From: [Tonsager, Cindy](#)
To: [Kabele, Megen \(MPCA\)](#)
Cc: [Droste, Bill](#); [Smith, Matt](#)
Subject: Dakota County Comment EAW Pine Bend Vertical Expansion
Date: Wednesday, December 13, 2023 8:34:34 AM
Attachments: [image001.png](#)
[Dakota County Comment EAW Pine Bend Vertical Expansion.pdf](#)

Thank you for the opportunity to review the Environmental Assessment Worksheet (EAW) for the project to develop and permit a vertical expansion over the Phase 5 and 6 areas, to increase the permitted capacity of the existing Pine Bend Landfill in Inver Grove Heights. County Physical Development Staff reviewed the document and offer the attached comments for consideration.

Thank you for the opportunity to review the Environmental Assessment Worksheet (EAW) for the project to develop and permit a vertical expansion over the Phase 5 and 6 areas, to increase the permitted capacity of the existing Pine Bend Landfill in Inver Grove Heights. County Physical Development staff reviewed the document and offer the following comments for consideration.

Figure 1. 1916 plat map – 116.79 acre parcel owned by J. Chapron

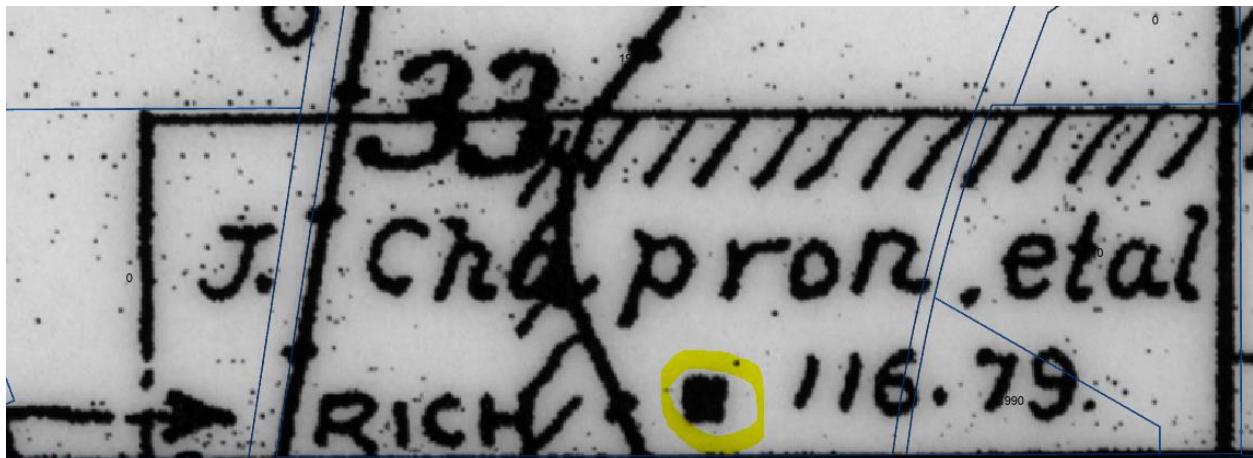
- There is no Table 2 or Table 3 in Appendix D.
- There is habitation, likely an old farmstead mapped in the 1896 and 1916 plat maps and visible on the 1945 and 1951 air photos. There is no Well and Boring Sealing Record for a domestic well at this location. See attached figure. This area is still accessible. so a well search should be conducted and the well(s) ultimately sealed by a licensed well contractor. A magnetometer is the best, sometimes only way to locate wells that are below grade. Dakota County can help locate a wells using a magnetometer by calling 952-891-7000. Magnetometers work best on a clear site free from large metal obstructions. A Dakota County well inspector must be present during any well searches to rule out the presence of a well.

Habitation in SE quarter of Section 33 on Pine Bend Landfill at 2495 117th St E, Inver Grove Heights. Area of possible one or more unsealed domestic wells is circle in yellow in figures below.
